# COUNTY OF SANTA CRUZ

### BOARD OF SUPERVISORS AGENDA: FEBRUARY 26,2002 @ 7:30 p.m.

#### SUBJECT: CONTINUED PUBLIC HEARING TO CONSIDER:

1. PLANNING COMMISSION'S DENIAL OF APPLICATION #98-0148 TO CONSTRUCT 12 SEMI-DETACHED AND 46 DETACHED TOWNHOUSES IN THREE PHASES, ON A COMMON PARCEL WITH A MINIMUM RESTRICTED COMMON AREA OF 3,000 SQUARE FEET MINI " PER DWELLING UNIT; THREE NEW ROADS; "BOWMAN COURT", "BOWMAN CIRCLE", AND AN EMERGENCY ACCESS DRIVE; FIVE PARKING AREAS TOTTALLING 28 SPACES; DRAINAGE SYSTEMS DISCHARGING TO AN EXISTING POND AND TO AN EXISTING GULLY ALONG PORTER GULCH CREEK; TWO RETAINING WALLS UP TO FOUR FEET IN HEIGHT AND **ONE** RETAINING WALL UP TO EIGHT FEET IN HEIGHT; AND AN OVERLOOK. GRADING ON PARCEL 037-251-21 CONSISTS OF 4,800 CUBIC **YARDS** OF CUT AND FILL, AND GRADING ON PARCEL 037-251-22 CONSISTS OF 5,200 CUBIC YARDS OF CUT AND FILL. THE REAR OF BOTH PARCELS WOULD BE RETAINED AS OPEN SPACE. THE PROJECT REQUIRES A SUBDIVISION, ROADWAY/ROADSIDE EXCEPTIONS, A RIPARIAN EXCEPTION FOR THE DRAINAGE SYSTEMS RELEASING INTO THE RIPARIAN CORRIDOR, AND PRELIMINARY GRADING APPROVAL; AND

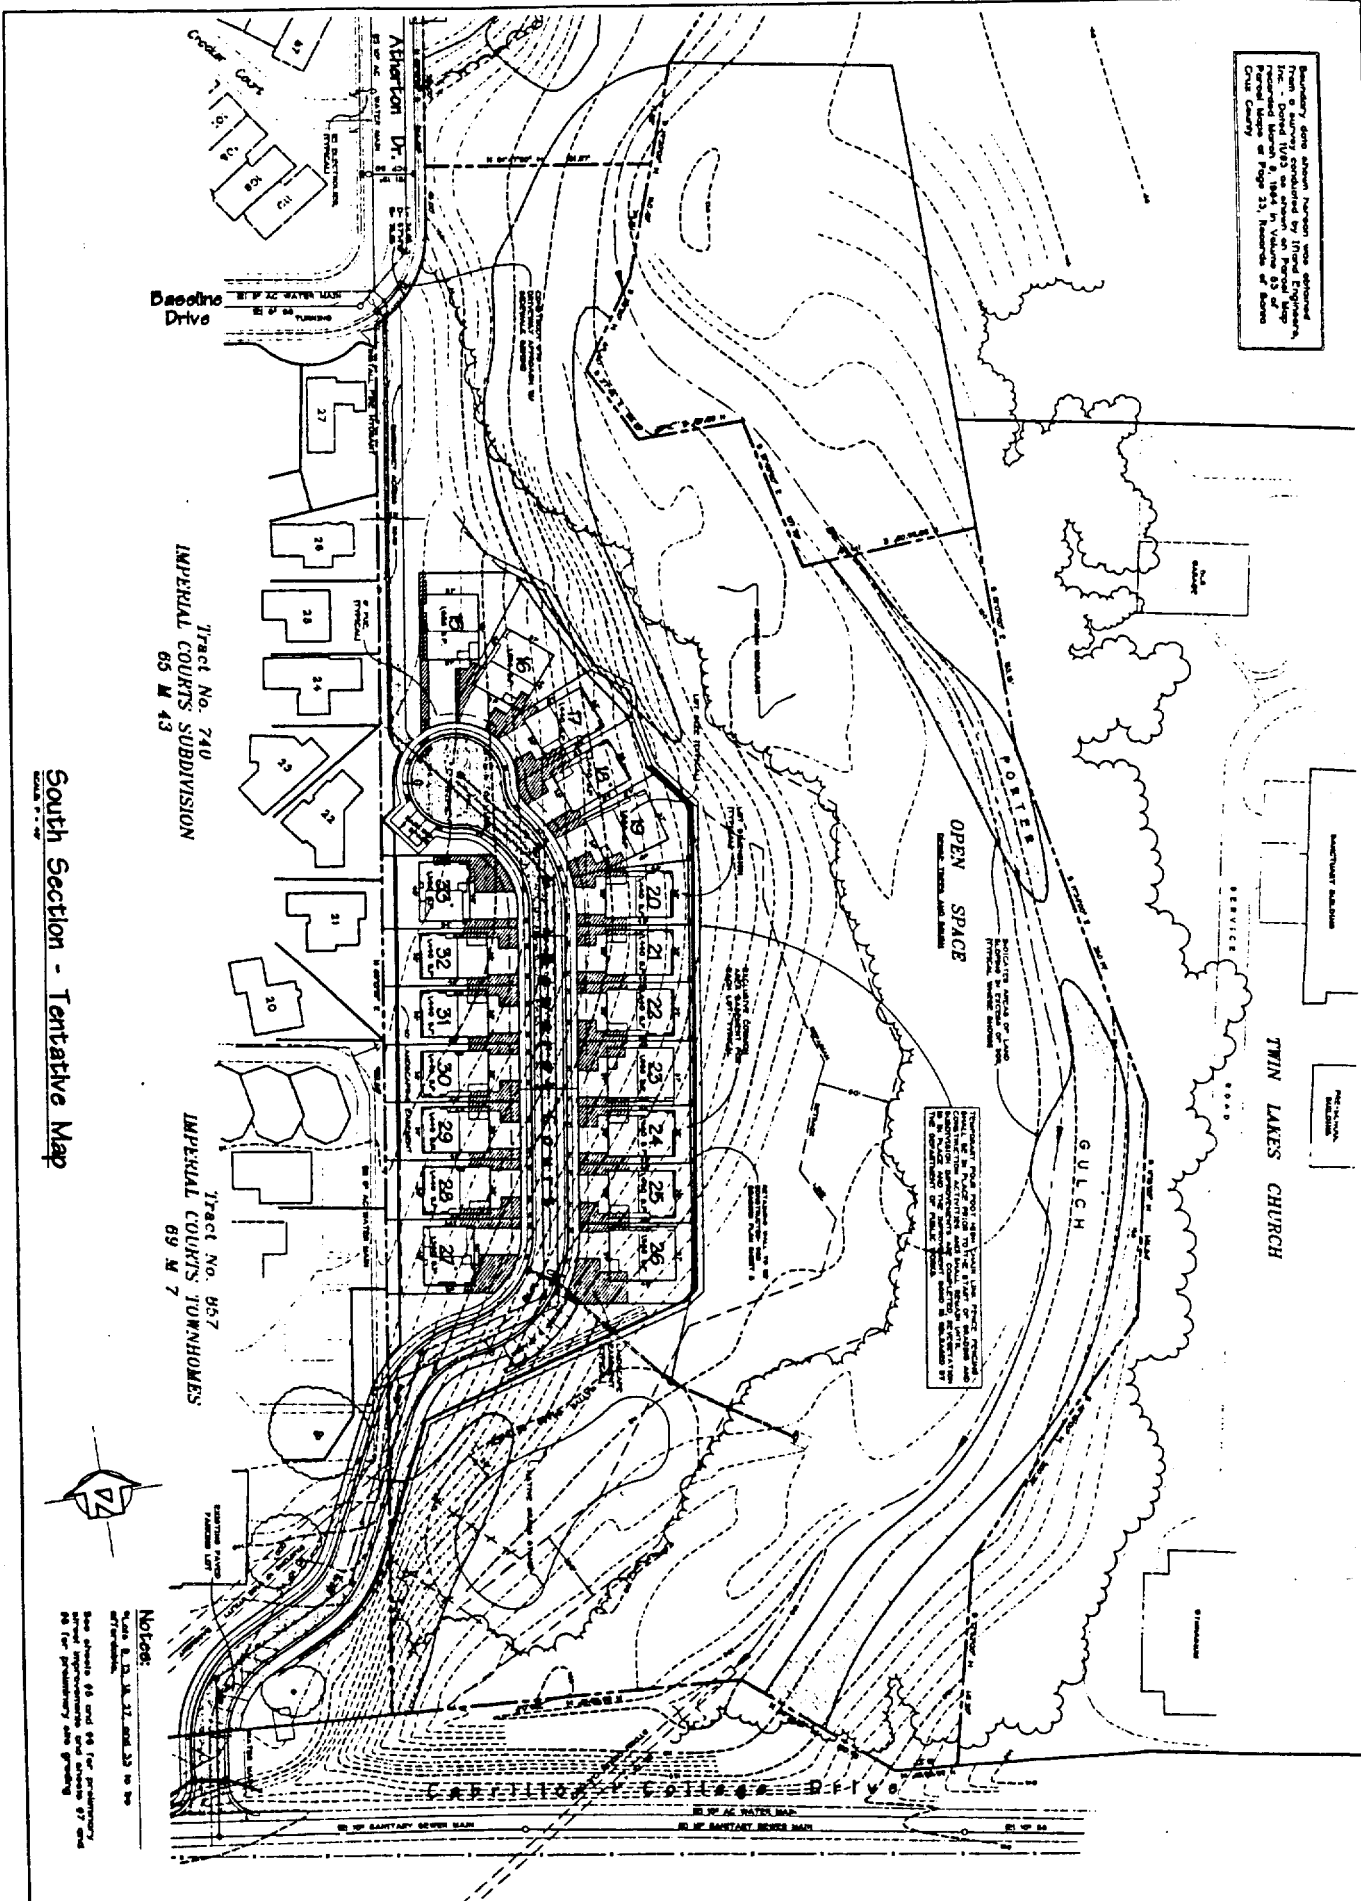
A new 10" public water main shall connect from Atherton Drive at Baseline Drive through the access road and Bowers Court to the existing 10" public water main in Cabrillo College Drive, with a connection to the 6" public water main in Imperial Courts Tract 857 (see Civil Sheet 4).

SHOW on the plans three new public fire hydrants, connected to the existing 10" water main, are required on Atherton Drive (see Civil Sheets 3 & 4).
